TB KLN022

## TECHNICAL BULLETIN

**From:** Tony Knapp, Product Support Engineer.  
**Date :** 8 July 2019  
**Product :** Xtralift 2.0 (Kleemann)  
**Subject :** Machine 3 phase isolation switch UCM  
**Pages :** 2

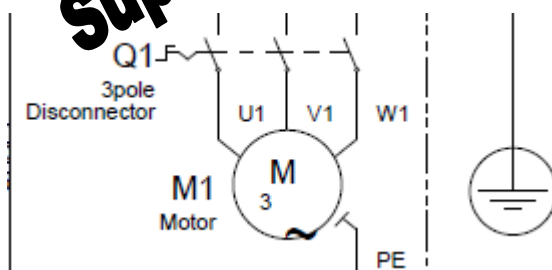
During the installation of Kleemann Traction lift, a sub contractor had an UCM in the upwards direction. The installer had fitted and wired the Q1 motor isolation switch as per drawing (refer to extract below).

The motor isolation switch Q1 was off but they attempted to move the lift down on recall, the brake lifted and the lift rolled up the shaft due to there being no power to the motor to hold the lift in position and then drive in the correct direction.

The lift stopped as the recall signal was dropped.

**The Q1 switch should not be used to isolate the motor.** Instead the car top stop switch should be used. Kleemann have removed the Q1 switch from all lifts manufactured post Jan 19 and will supply an extra stop switch instead.

5.12.1.11.1 states a stopping device labelled 'STOP' should be within 1m of the drive machine. So only needs to be a stop button not a three phase rotary switch.
